Re: Third Submission Review – Urban Cottages Jewell – Zoning Map Amendment, Site Plan
w/Adjustment and Final Plat
Application Number: **DA-2309-00**
Case Numbers: **1984-2057; 2022-4026-00; 2022-3022-00**

URBAN COTTAGES JEWELL

SITE PLAN WITH ADJUSTMENTS

SHEET NUMBER
SP1
2 OF 38

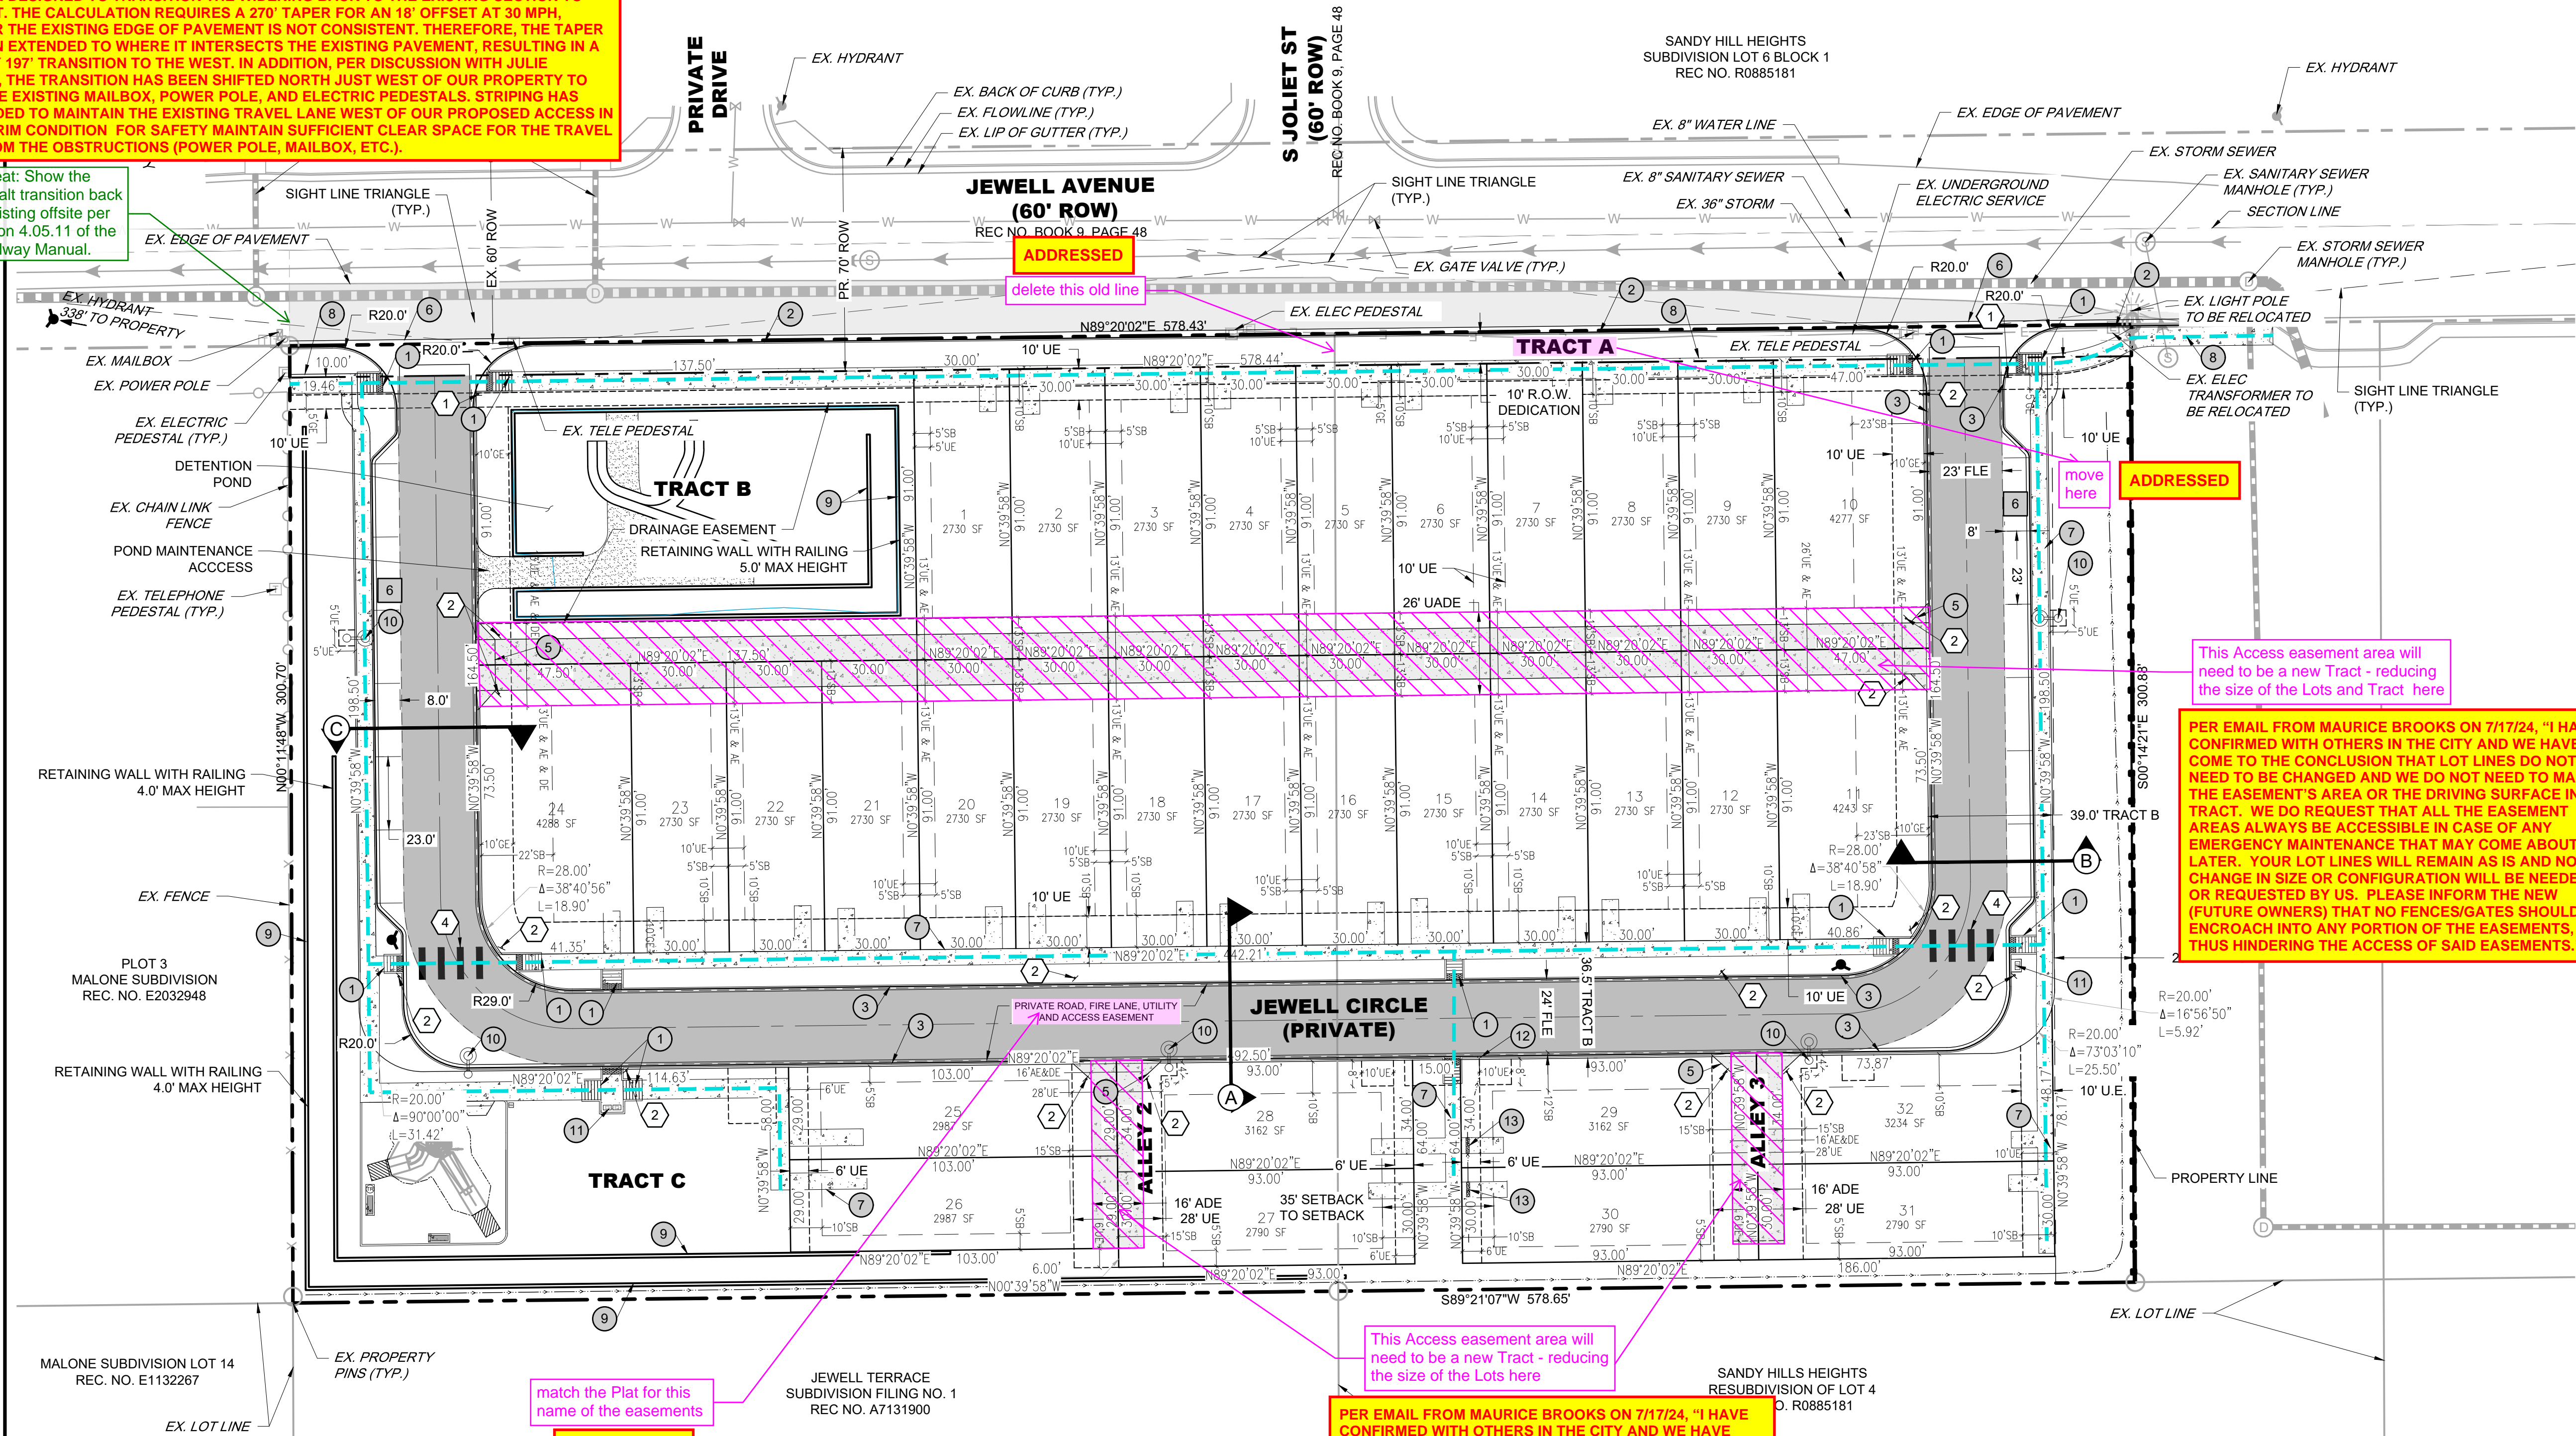
Repeat: Show the asphalt transition back to existing offsite per section 4.05.11 of the Roadway Manual.

RESPONSE: IN ACCORDANCE WITH SECTION 4.05.11 OF THE ROADWAY MANUAL, A TAPER HAS BEEN DESIGNED TO TRANSITION THE WIDENING BACK TO THE EXISTING SECTION TO THE WEST. THE CALCULATION REQUIRES A 270' TAPER FOR AN 18' OFFSET AT 30 MPH, HOWEVER THE EXISTING EDGE OF PAVEMENT IS NOT CONSISTENT. THEREFORE, THE TAPER HAS BEEN EXTENDED TO WHERE IT INTERSECTS THE EXISTING PAVEMENT, RESULTING IN A ROUGHLY 197' TRANSITION TO THE WEST. IN ADDITION, PER DISCUSSION WITH JULIE BINGHAM, THE TRANSITION HAS BEEN SHIFTED NORTH JUST WEST OF OUR PROPERTY TO AVOID THE EXISTING MAILBOX, POWER POLE, AND ELECTRIC PEDESTALS. STRIPING HAS BEEN ADDED TO MAINTAIN THE EXISTING TRAVEL LANE WEST OF OUR PROPOSED ACCESS IN THE INTERIM CONDITION FOR SAFETY MAINTAIN SUFFICIENT CLEAR SPACE FOR THE TRAVEL PATH FROM THE OBSTRUCTIONS (POWER POLE, MAILBOX, ETC.).

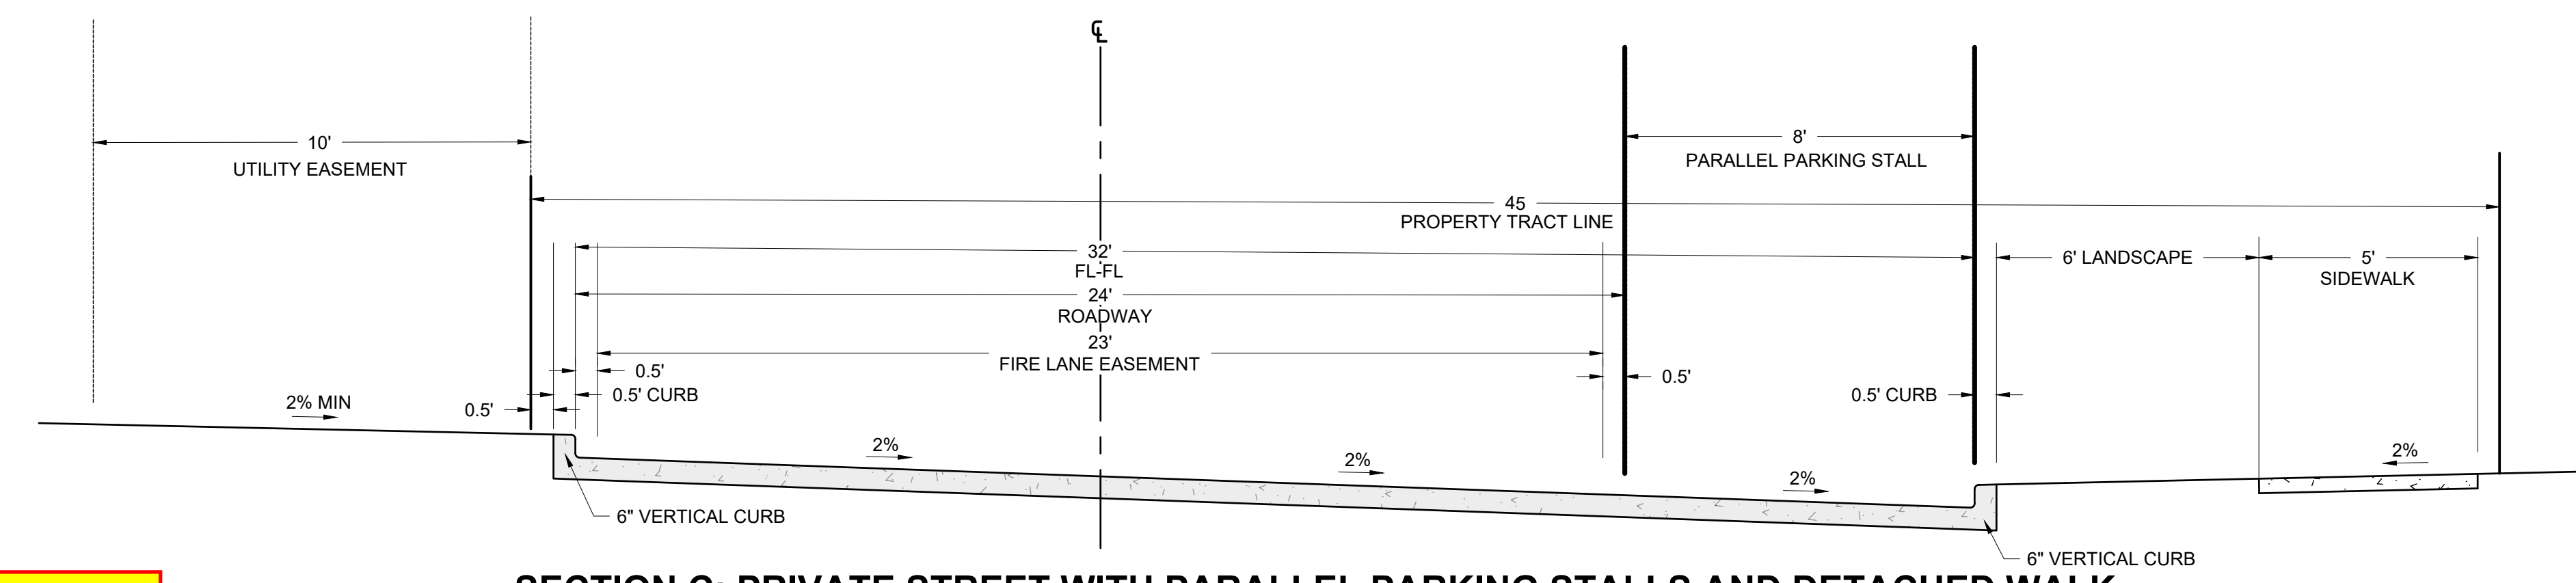
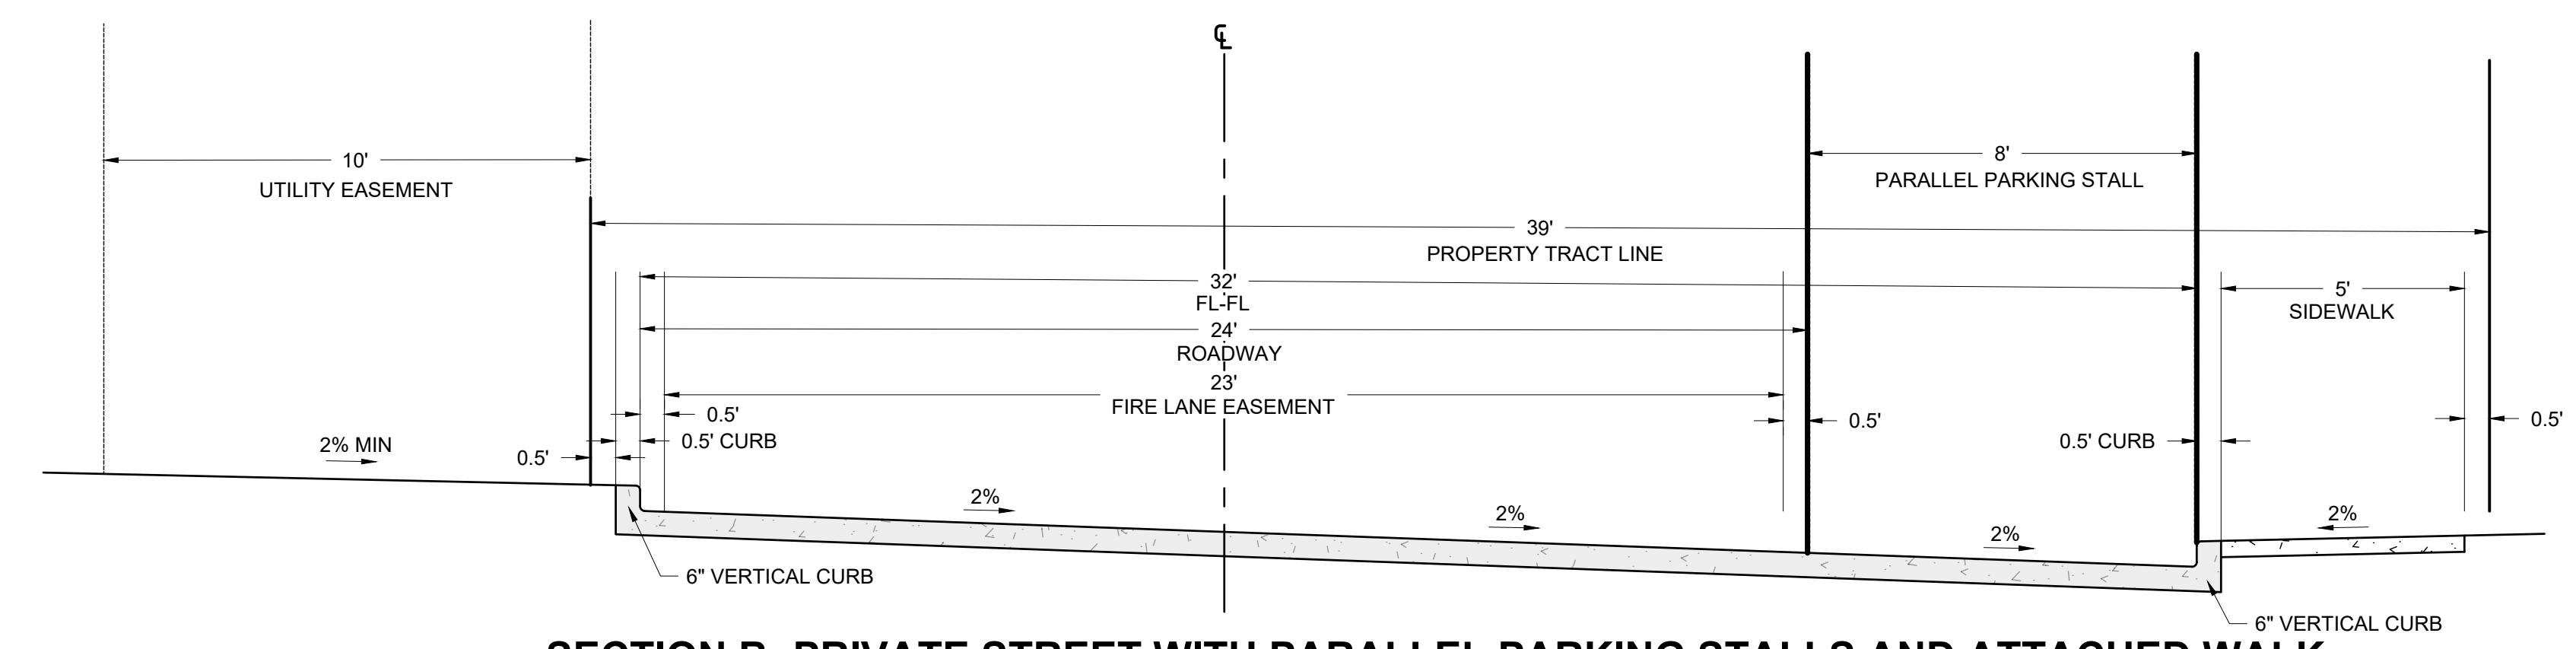
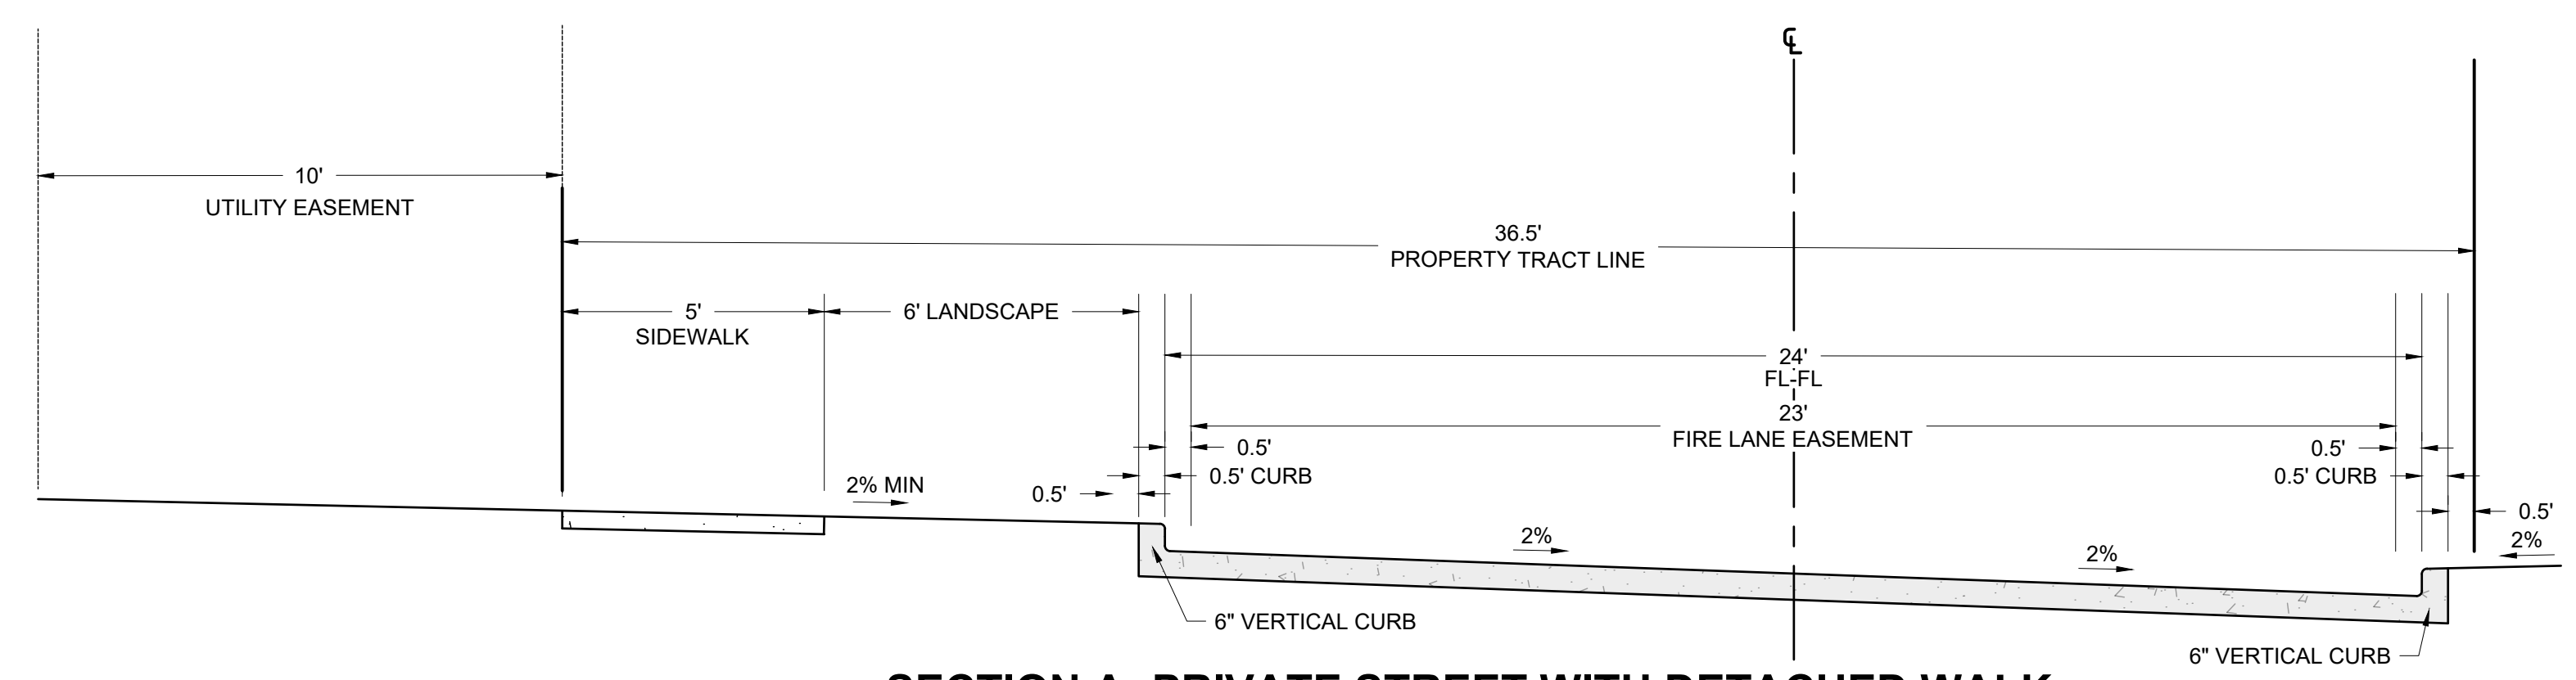
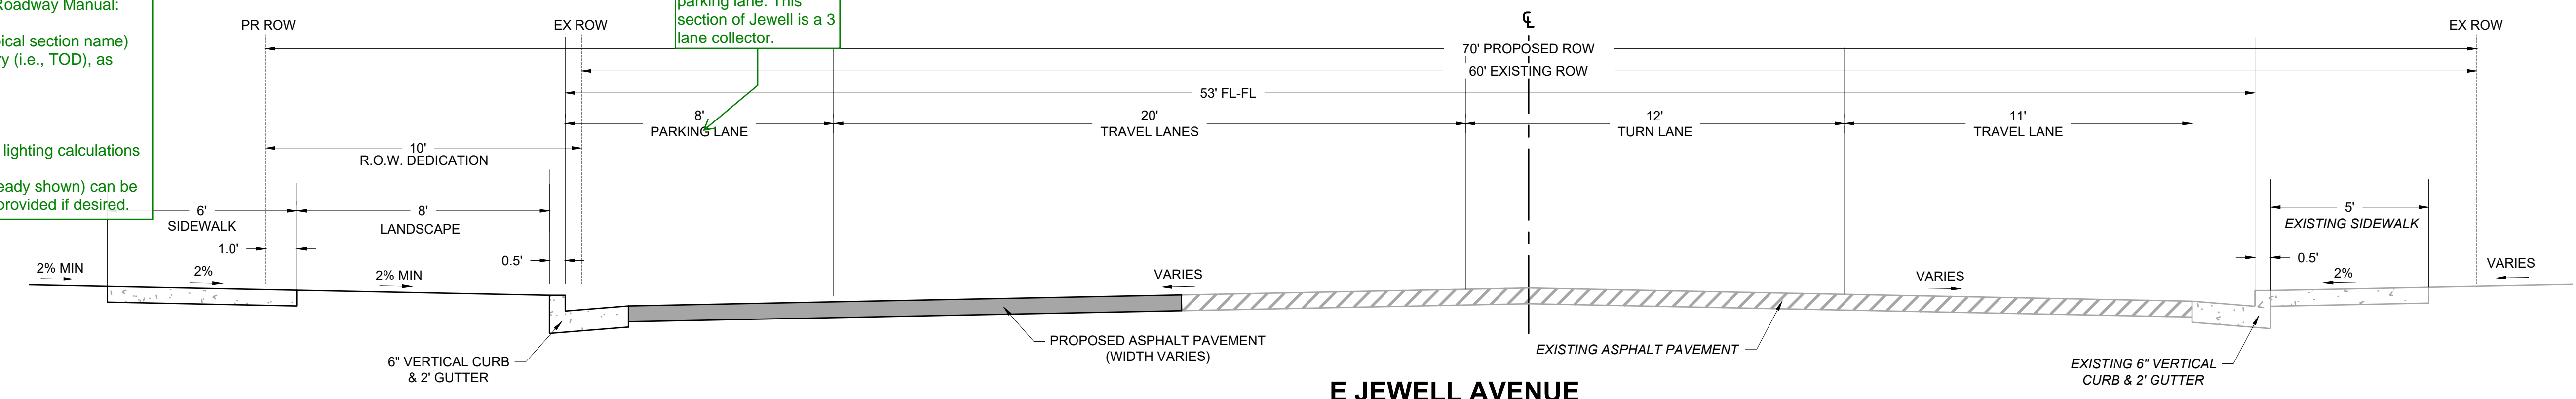
Public streets shall have public streetlights in conformance with COA standards.

For each street, identify the following information as part of the site plan submittal in conformance with Section 2.12.0.1 of the Roadway Manual:

- Roadway Classification (typical section name)
- Adjacent Land Use Category (i.e., TOD), as applicable
- Number of lanes
- Back-to-back curb width
- Pedestrian Activity Level
- Pavement Type: R3, for all lighting calculations

This information (if its not already shown) can be added to the street sections provided if desired.

Remove label for parking lane. This section of Jewell is a 3 lane collector.

NOTES HAVE BEEN ADDED NEXT TO THE JEWELL AVE SECTION.
